PLANNING COMMISSION MEETING

Thursday, December 14, 2023 at 6:30 PM
Council Chambers, 60 West Main, Hyrum, Utah

JARED CLAWSON MINI-SUBDIVISION
475 SOUTH 800 EAST
PLANNING COMMISSION MEETING
NOVEMBER 9, 2023

BYWATER ESTATES MINI SUBDIVISION
340 NORTH 400 WEST
PLANNING COMMISSION MEETING
DECEMBER 14, 2023

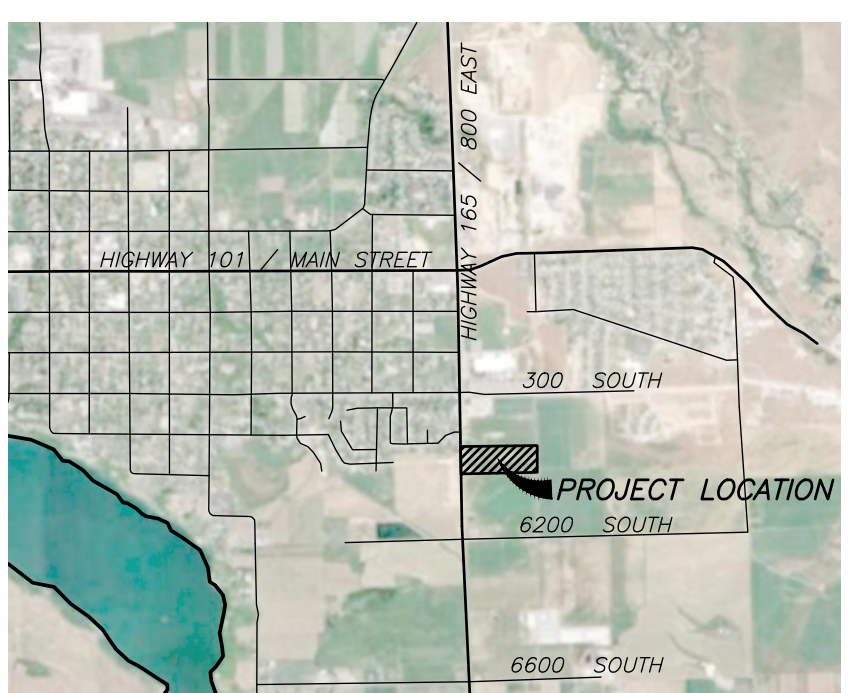
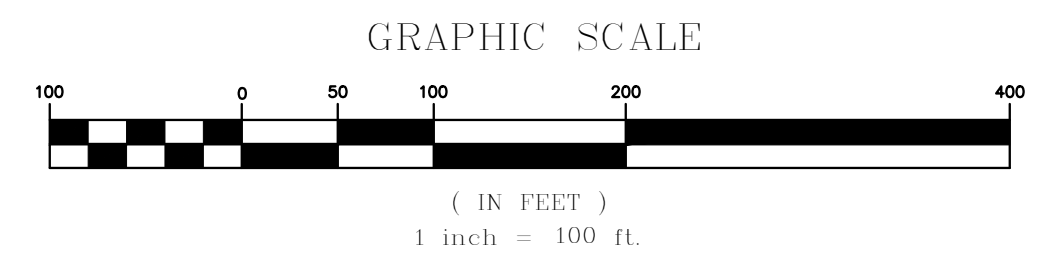
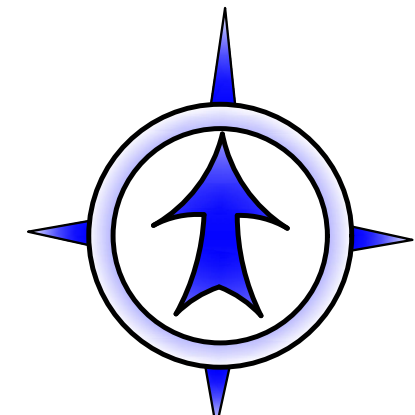
Remainder parcel shall not be addressed until future development.

Utilities need to be updated to match current locations. (water, sewer, irrigation)

BLACKSMITH RENTALS
280 NORTH 800 EAST
PLANNING COMMISSION MEETING
DECEMBER 14, 2023

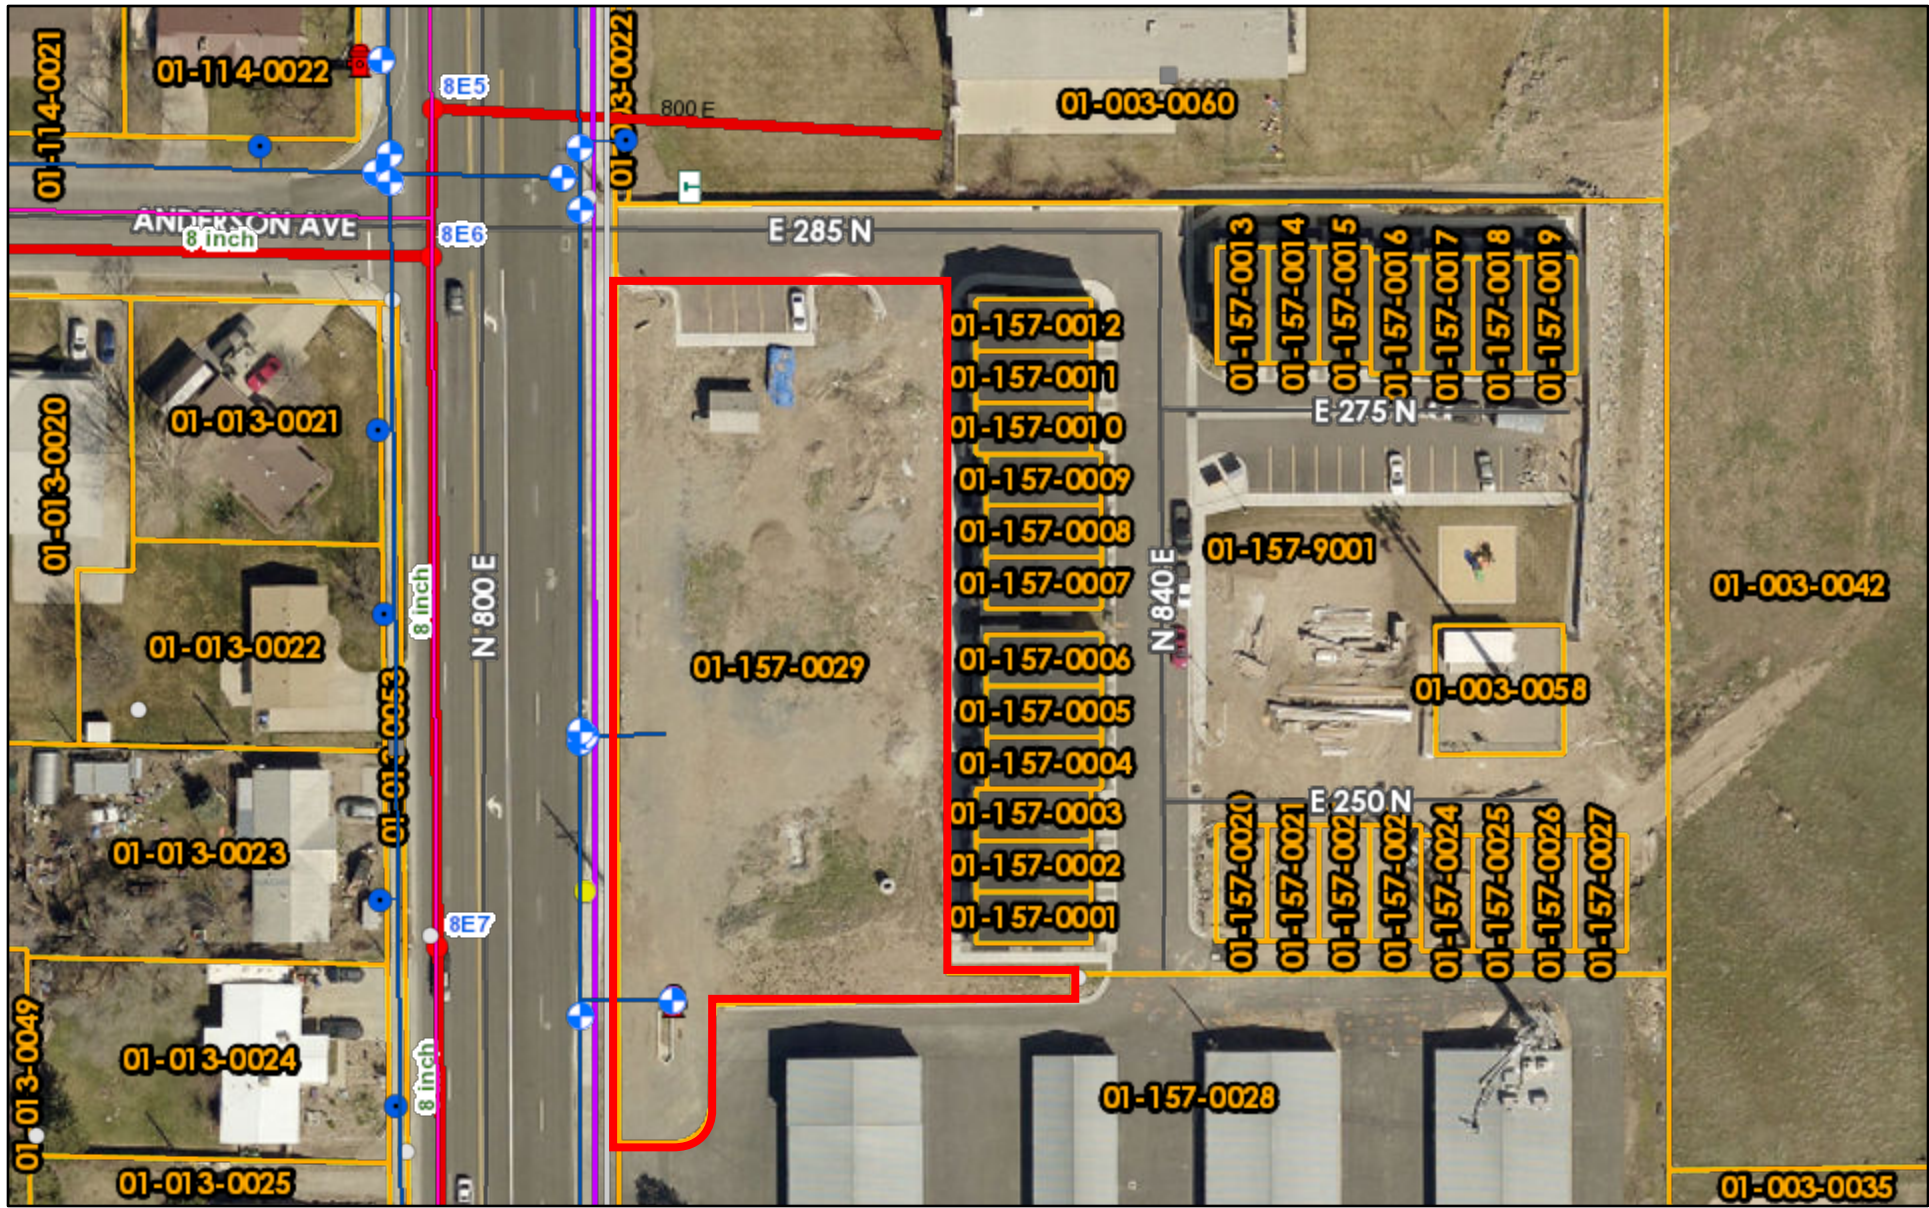
SELECTION OF PLANTINGS SHOULD BE SALT TOLERANT.

NEED A PLAN TO SHOW RELOCATION OF FIRE HYDRANT. COORDINATE WITH FIRE DEPARTMENT FOR LOCATION.

BYWATER ESTATES SUBDIVISION

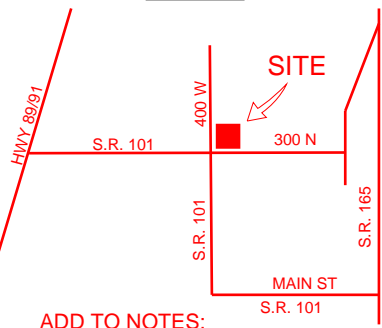
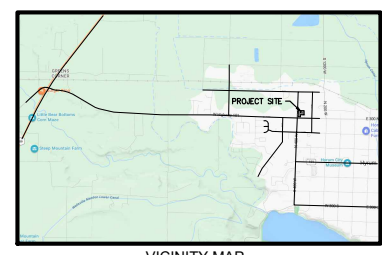
THIS VICINITY MAP IS NOT GOING TO BE LEGIBLE ON REPRODUCTION. A SIMPLE N.T.S. VICINITY AS BELOW IS ADEQUATE.

ADD TO NOTES: STREET TREES PER HCC 16.28.020(H)

CONTAINS: 76795.92 SQ.FT. OR 1.76 AC.
PLEASE PROVIDE METES AND BOUNDS DESCRIPTION FOR EACH LOT PER HCC 16.28.020 (D) NARRATIVE:

CURTIS KNIGHT – PETITION FOR REZONE
350 EAST 300 NORTH
PLANNING COMMISSION MEETING
DECEMBER 14, 2023

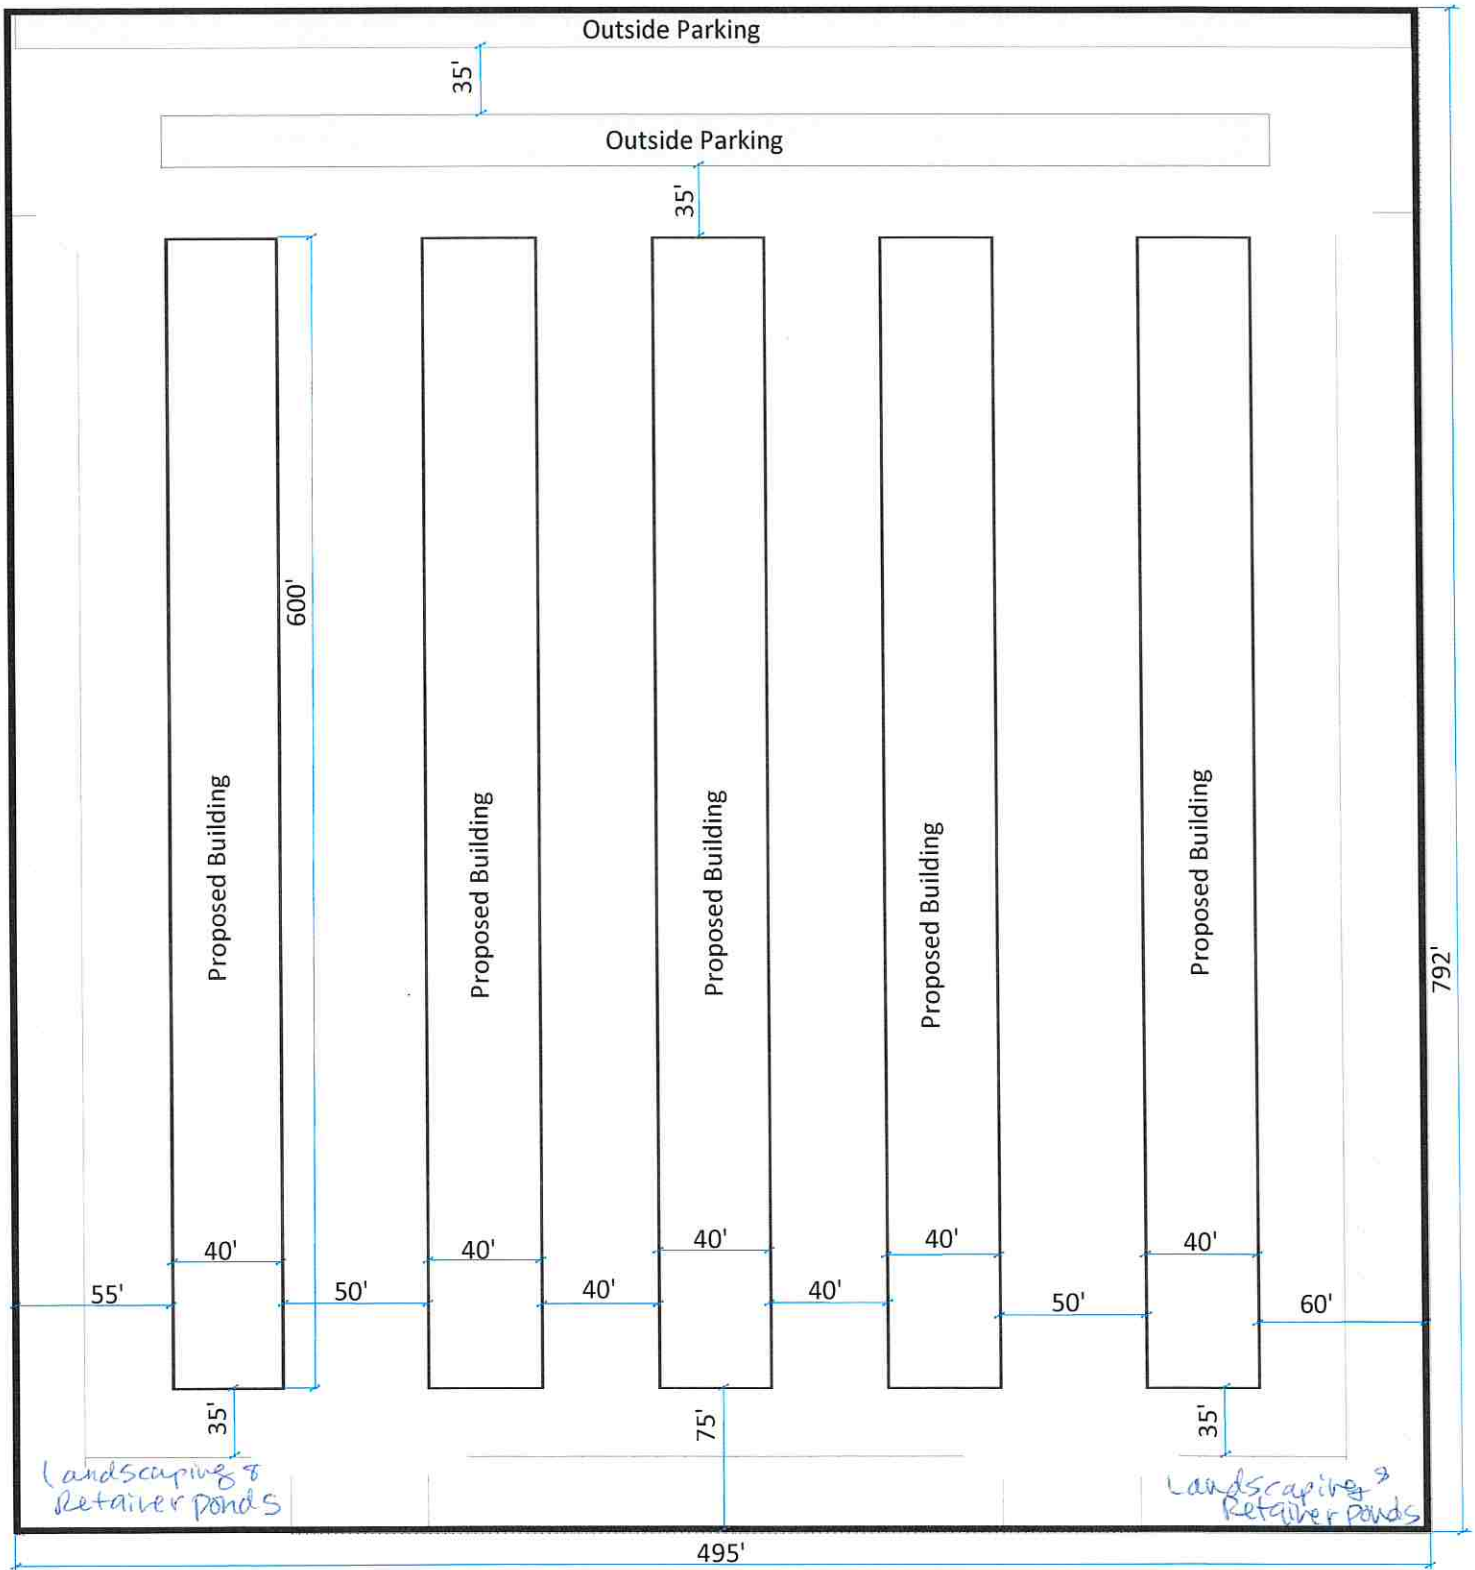
THIS IS NOT A SITE PLAN APPROVAL FOR STORAGE UNITS. A SITE PLAN WILL NEED TO BE A SEPARATE APPLICATION IF THE ZONE CHANGE IS APPROVED BY CITY COUNCIL.

ROAD RIGHT OF WAY WILL NEED TO BE PRESERVED ON THE SOUTH SIDE OF THE PROPERTY FOR 200 NORTH. BUILDING LAYOUTS WOULD NEED TO CHANGE TO MEET ZONING REQUIREMENTS WHERE THE BACK OF THE BUILDING FACES THE STREET.
